## Upper Gwynedd Township

### BOARD OF COMMISSIONERS ACTION ITEM REQUEST

**Re:** Moyer Blvd Preliminary/Final Land Development

# PRELIMINARY/ FINAL LAND DEVELOPMENT PLANS FOR MOYER BOULEVARD PROPERTY

**MOYER BOULEVARD PROPERTY**  
 TPN # 66-00-09616-02-1  
 WEST POINT PIKE AND MOYER BLVD  
 UPPER GWYNEDD TOWNSHIP, MONTGOMERY COUNTY, PA  
**RECORD SITE PLAN**

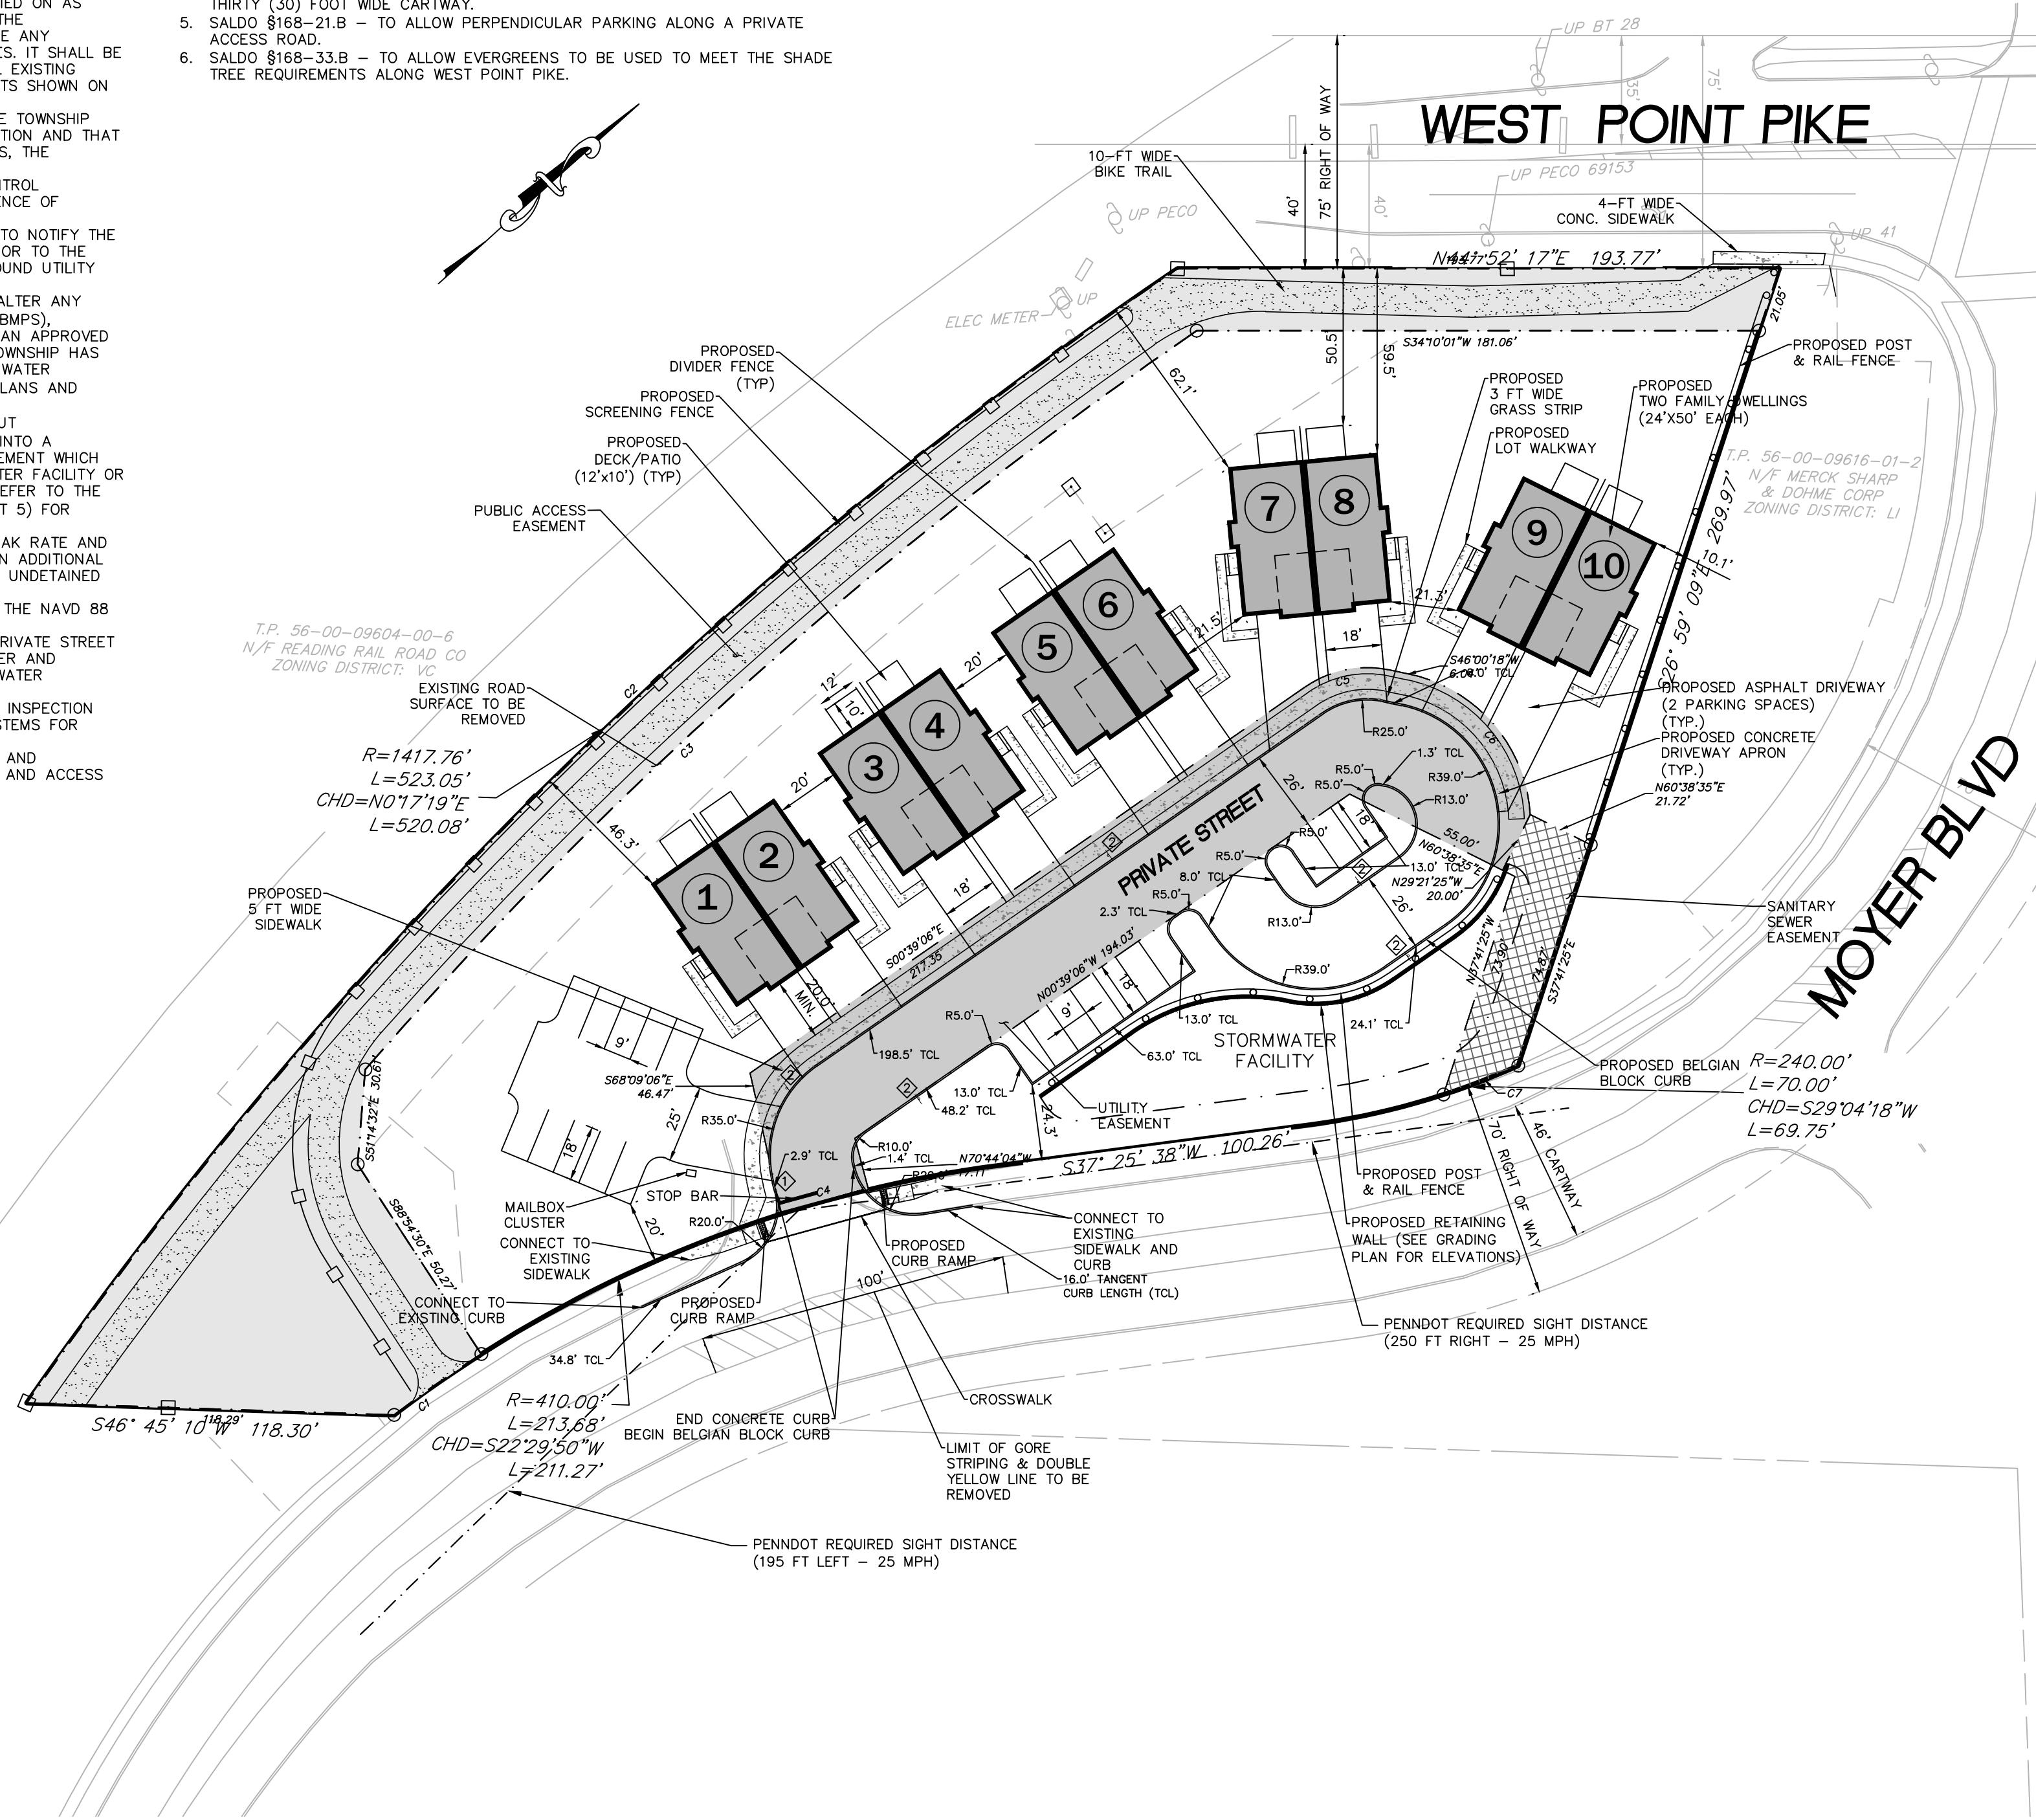
- a. The Zoning Hearing Board granted relief consisting of required dimensional and use variances in order to accommodate the subject development plan.  
**Response: Acknowledged.**
- b. It should be noted that sheet 3 of 17 the date of the Decision should be corrected to read: October 25, 2022.  
**Response: The date has been revised.**
- c. The Decision of the Zoning Hearing Board included reference to the fact (See II.9.H and I that state:

e. The Zoning Table at sheet 3 of 17 should be updated to provide a line for:

21. Plan Sheet 3 – provide tangent curb lengths for the proposed private street.

22. Plan Sheet 3 – provide adjacent property owner information.

23. Plan Sheet 3 – provide permanent markers for the existing utility easement in the rear yards of Units 1 through 8.

24. Plan Sheet 3 – Plan Note 19 – the benchmark could not be located (Sanitary MH with a rim elevation of 330.17).

25. Plan Sheet 3 – the proposed screening fence posts are shown penetrating the existing gas line (post hole digger).

26. Plan Sheet 3 – provide the owner of the existing utility easement and obtain permission for grading, bike trail construction and screening fence installation.

21. Plan Sheet 3 – provide tangent curb lengths for the proposed private street. *Item Satisfied.*
22. Plan Sheet 3 – provide adjacent property owner information. *Item Satisfied.*

23. Plan Sheet 3 – provide permanent markers for the existing utility easement in the rear yards of Units 1 through 8. *Item Satisfied.*
24. Plan Sheet 3 – Plan Note 19 – the benchmark could not be located (Sanitary MH with a rim elevation of 330.17). *Item Satisfied.*

25. Plan Sheet 3 – 7 – the proposed screening fence posts are shown penetrating the existing gas line (post hole digger). *Item Satisfied.*
26. Plan Sheet 3 – provide the owner of the existing utility easements and obtain permission for grading, bike trail construction and screening fence installation. *The Applicant states that permission for improvements in the easements don’t appear to be required. The Applicant continues to note that the fence and plantings have been adjusted to avoid the utility lines. Prior to plan approval, provide approval letters from PECO, North Wales Water Company and Upper Gwynedd Sewer Authority for the grading, landscaping, screen fencing and bike trail construction in their easements or near their facilities.*

41. Plan Sheet 2 – label Sanitary MH Rim 317.05 as BM.
42. Plan Sheet 3 – Plan Notes – renumber the notes after note number 19.
43. Plan Sheet 3 – Plan View – show four (4) concrete monuments along the Moyer Boulevard Right-of-Way Line (property corners, pc and pt).

**Response: The statement has been added to the Record Site Plan.**

**Response: The Zoning Table has been updated.**

**Response: The plans have been revised.**

**Response: The adjacent property owner information has been added to the plans.**

**Response: Monuments for the existing utility easement have been provided.**

**Response: The benchmark rim elevation has been revised.**

**Response: The proposed fence has been moved.**

**Response: Permission for improvements in the easement don't appear to be required. The proposed improvements are in the area of the previous Moyer Blvd and there is minimal grading and no cut in the area. The fence and plantings have been adjusted to avoid the utility lines. Additionally, the proposed plans will be coordinated with Peco during utility design.**
